MICHAEL DRISCOLL SCHOOL

OPM Monthly Project Update Report

January 2022

Change Order #8 Summary

SUBJECT: ASI - Data Jacks and Patch Panels Labeling

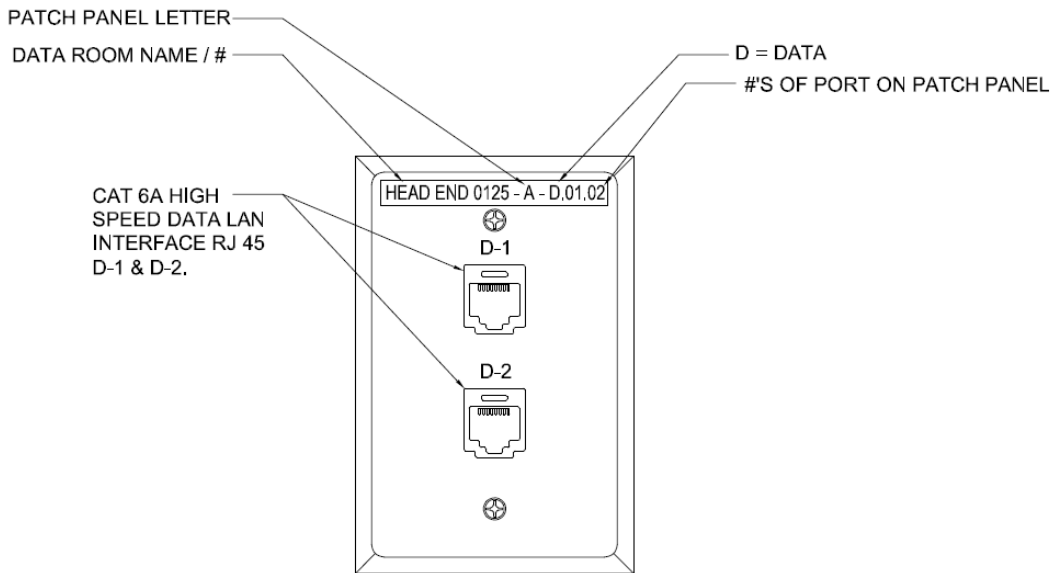
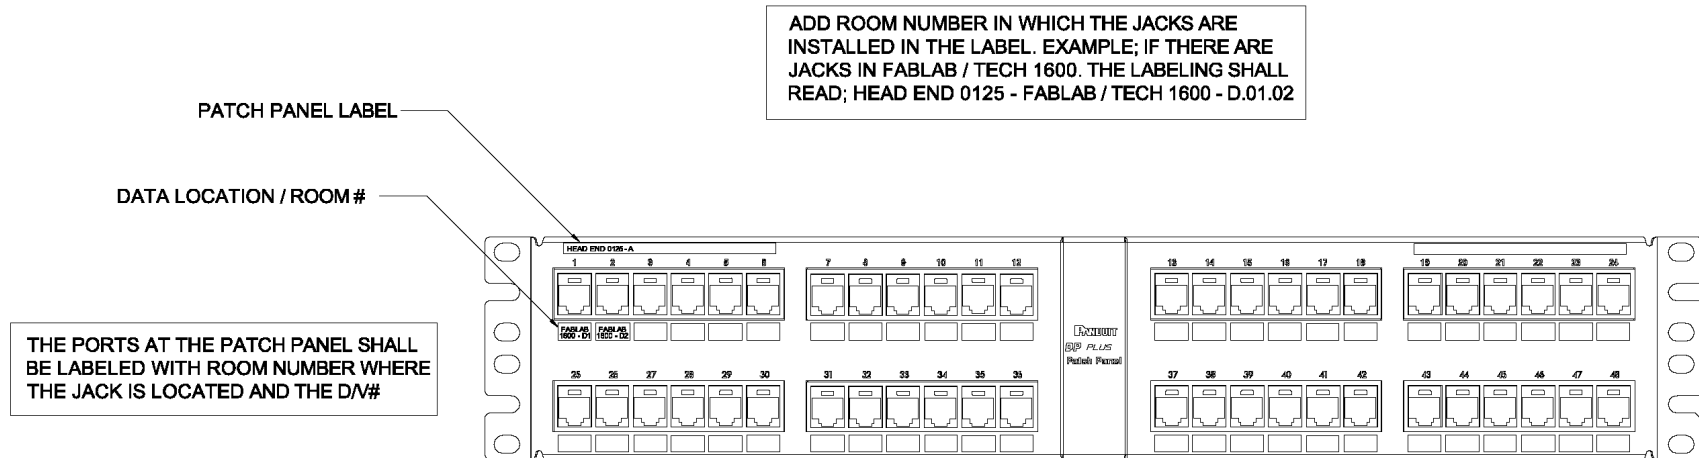
Per the Brookline IT Department, please label the patch panels as indicated below:

1 PATCH PANEL DETAIL
EX1 NOT TO SCALE

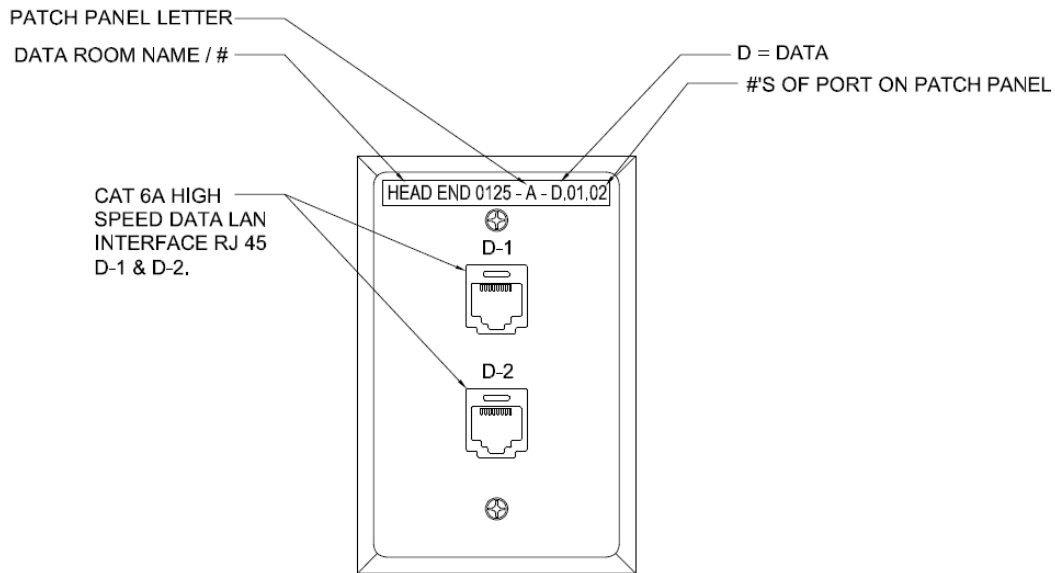
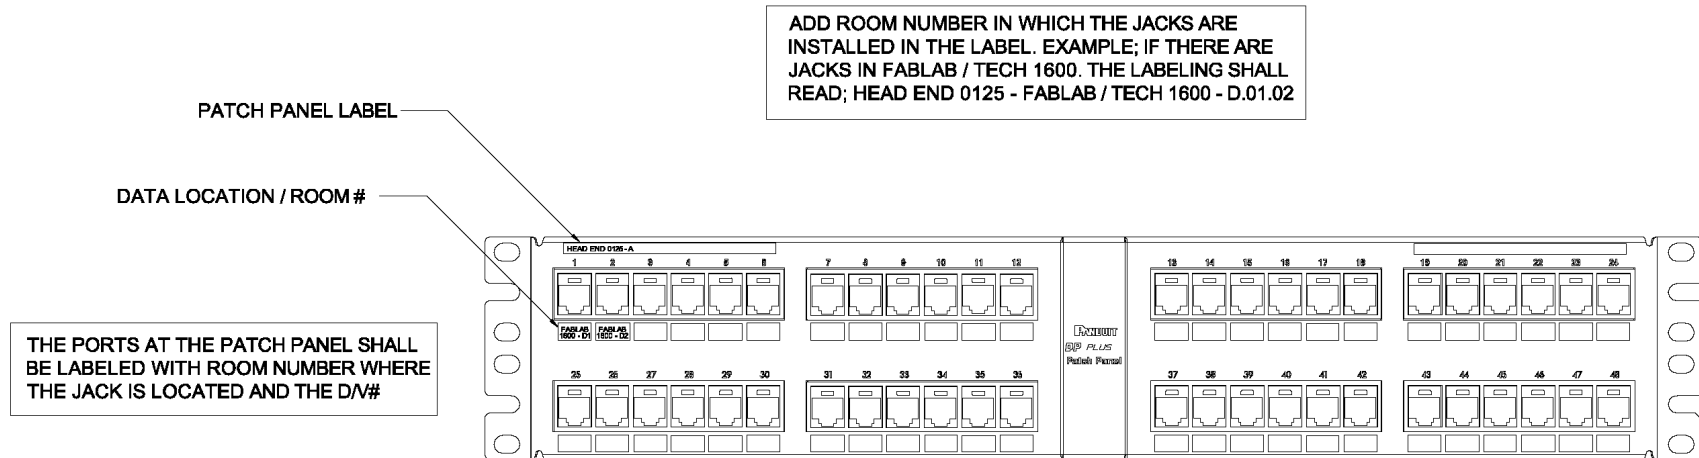
Per the Brookline IT Department, please label the patch panels as indicated below:

SUBJECT: Electrical Changes regarding Switchboard Submittal 260001-017-0

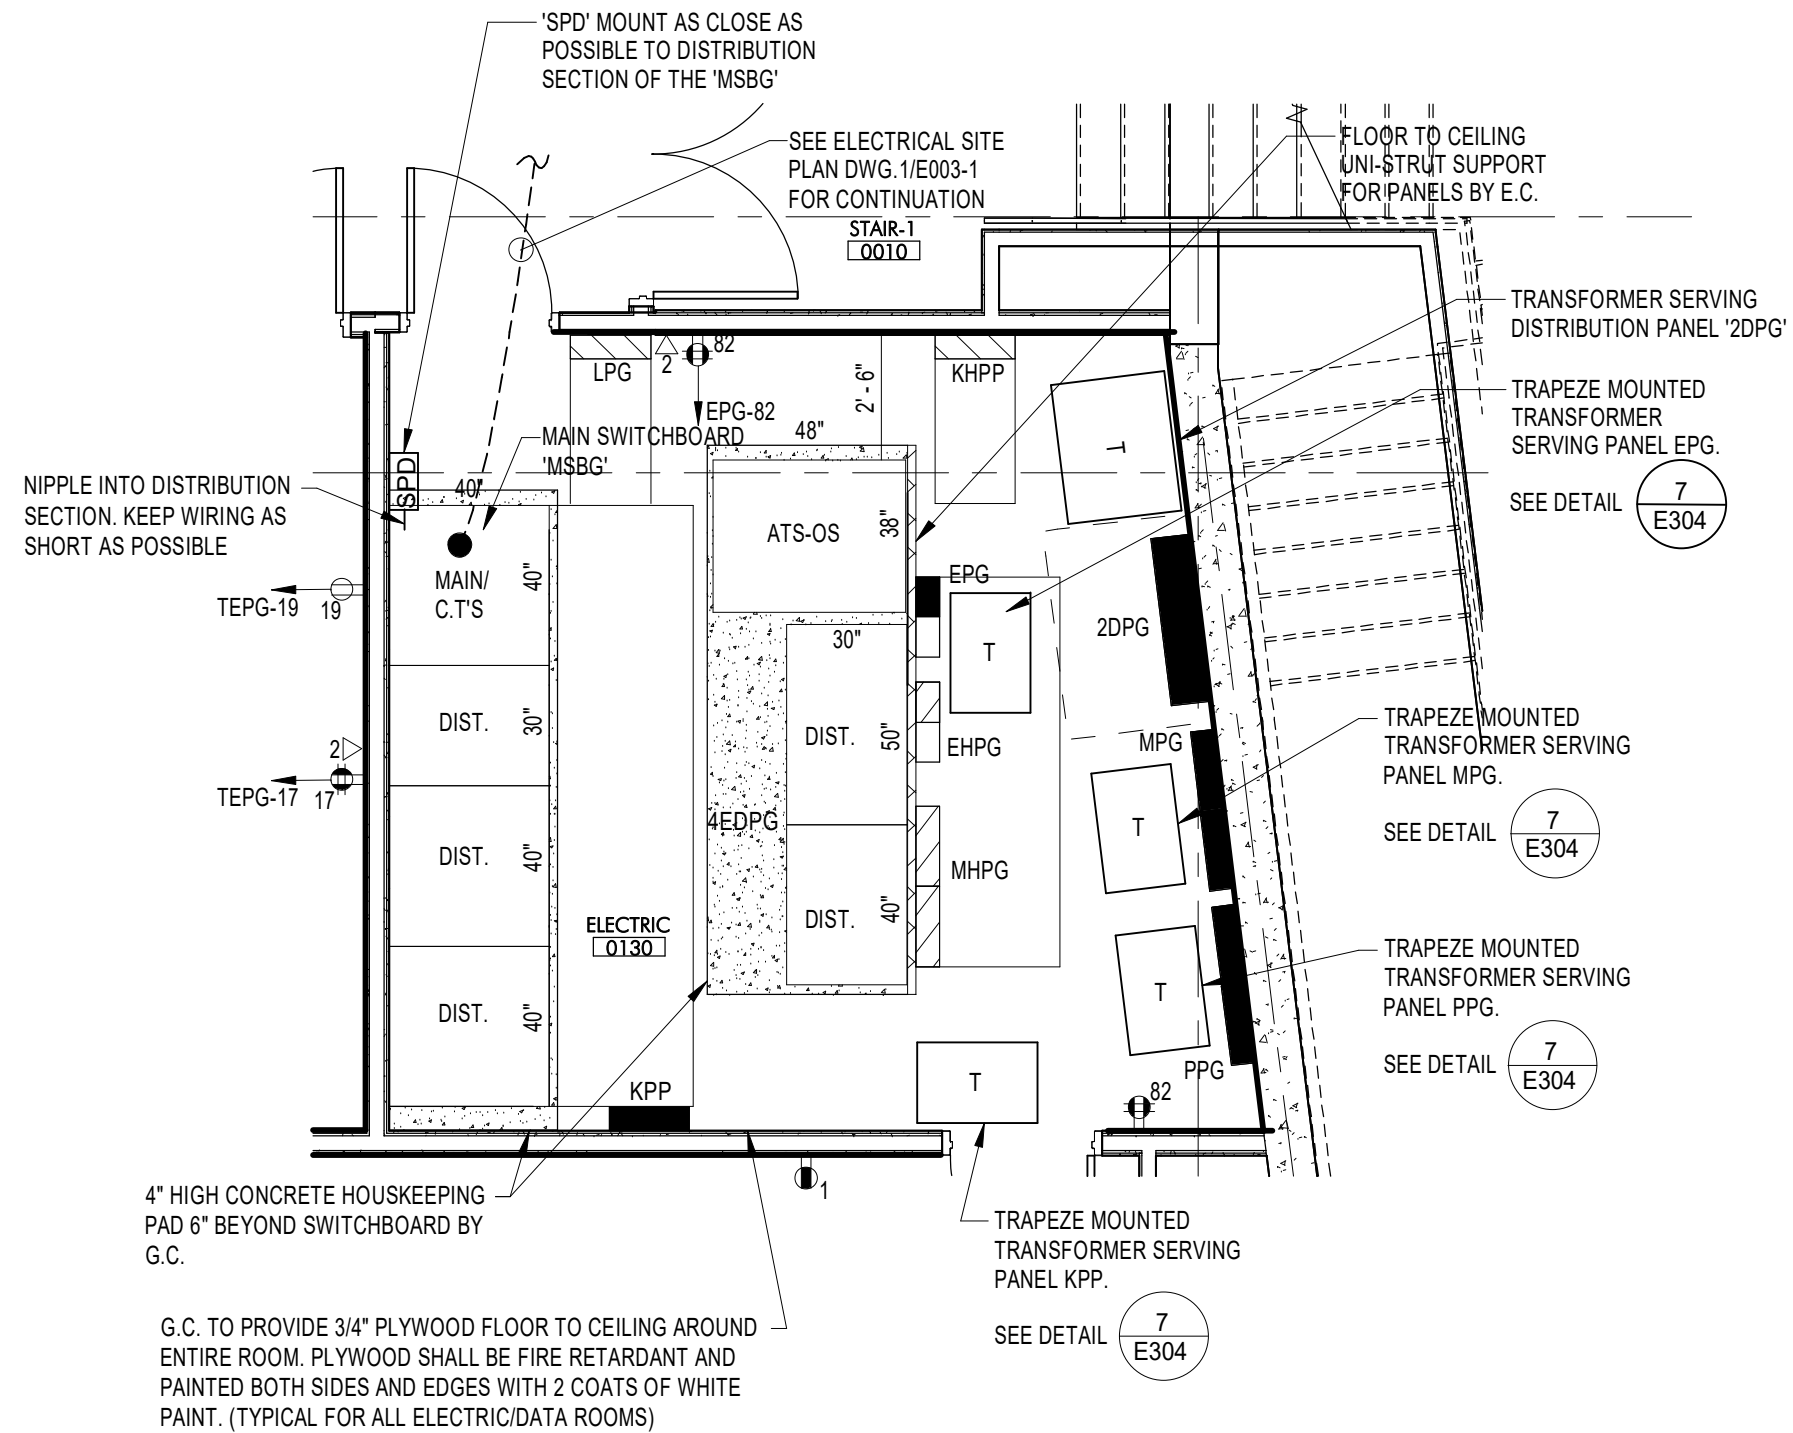
As a result of our shop drawing review for the "Switchboard" Submittal 260001-017-0, the following electrical changes are required as shown on the attached revised sketch SKE 0.02R. Please forward these changes to the Contractor.

SUBJECT: Electrical Changes regarding Switchboard Submittal 260001-017-0

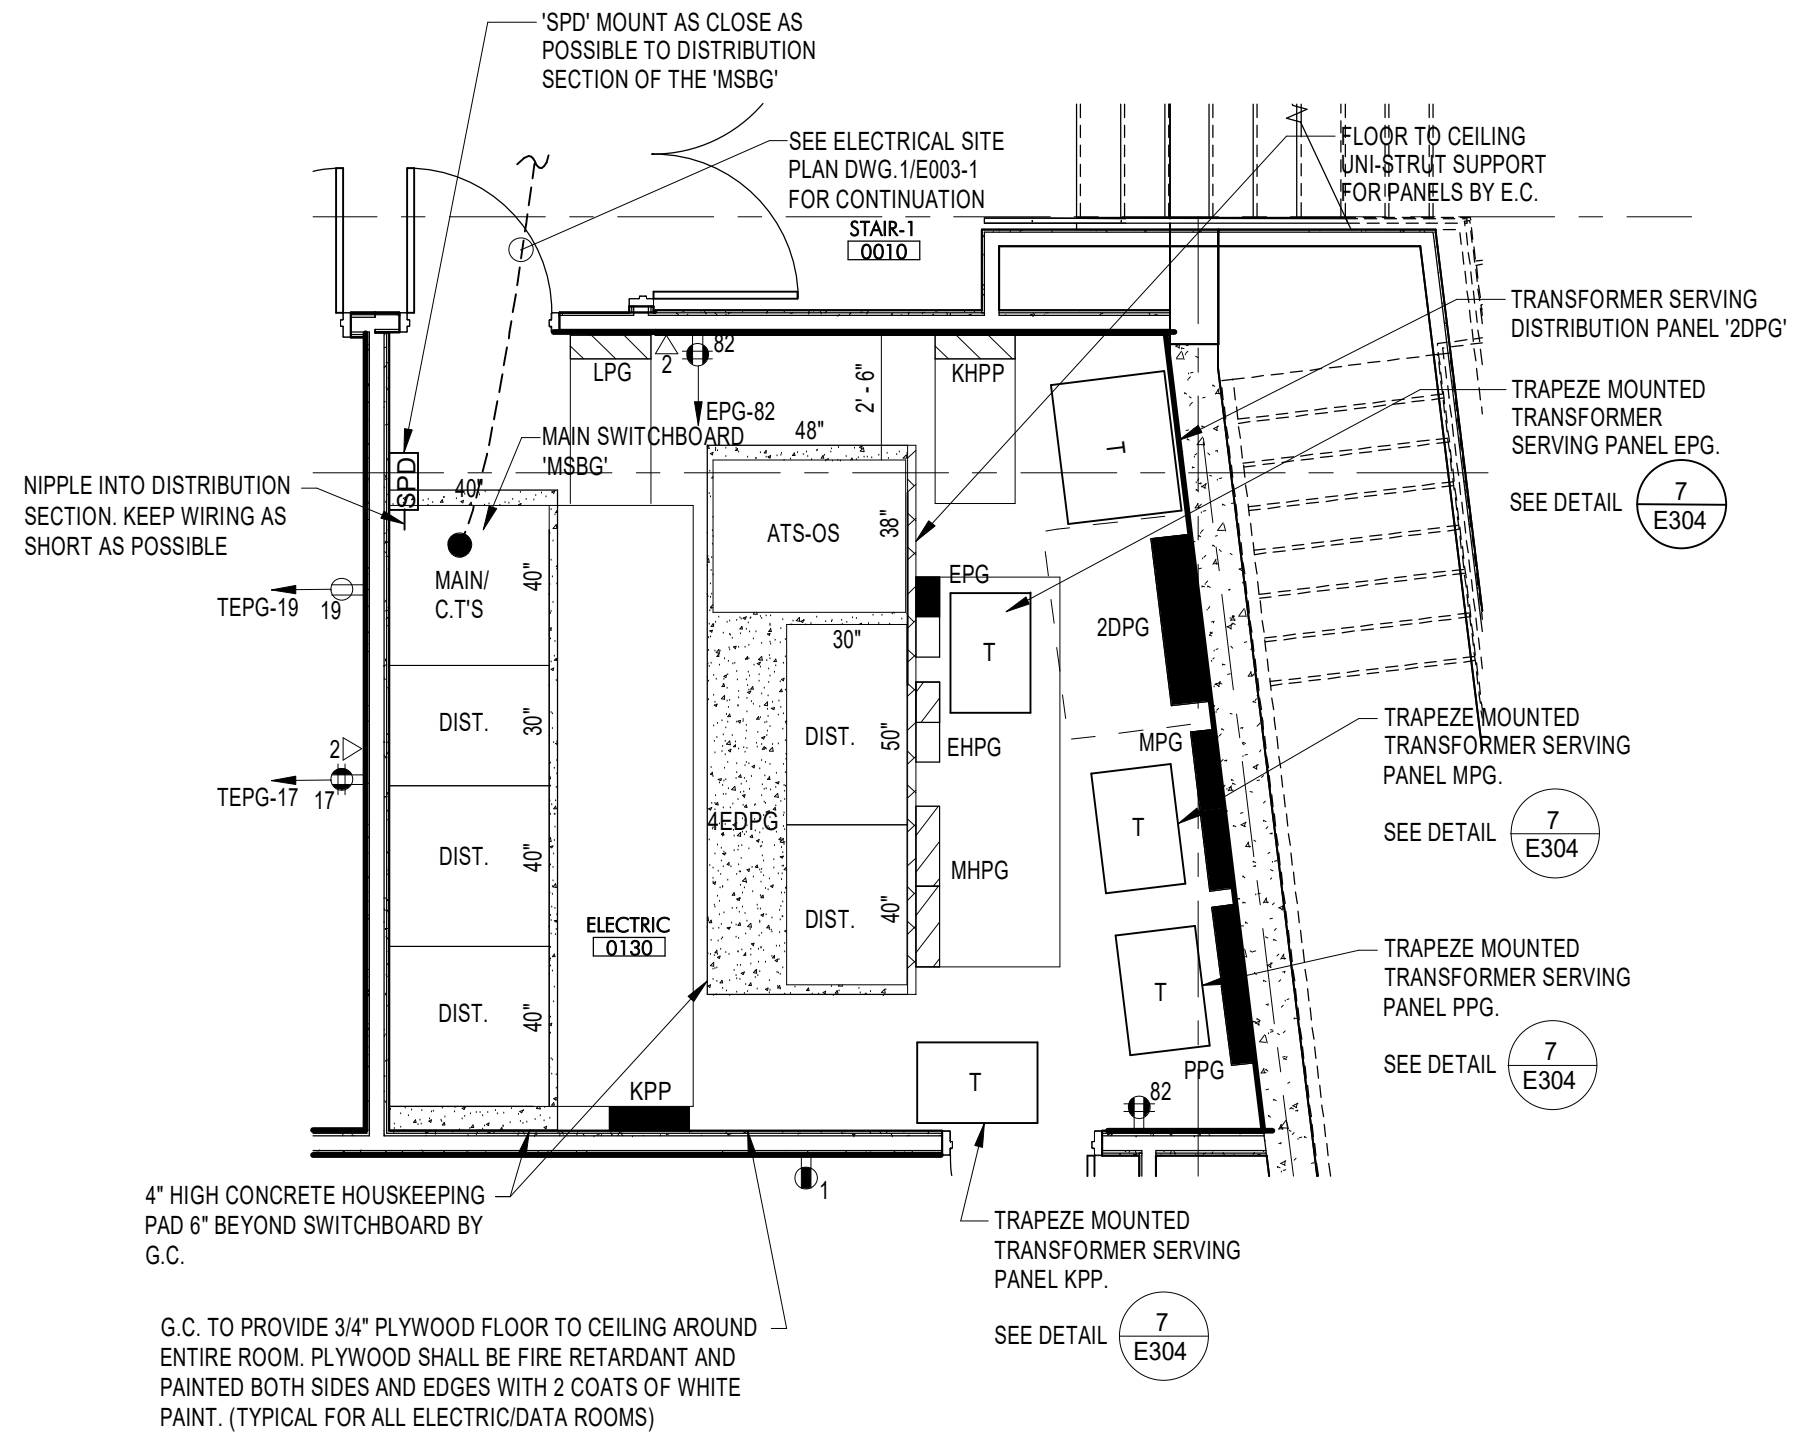
As a result of our shop drawing review for the "Switchboard" Submittal 260001-017-0, the following electrical changes are required as shown on the attached revised sketch SKE 0.02R. Please forward these changes to the Contractor.
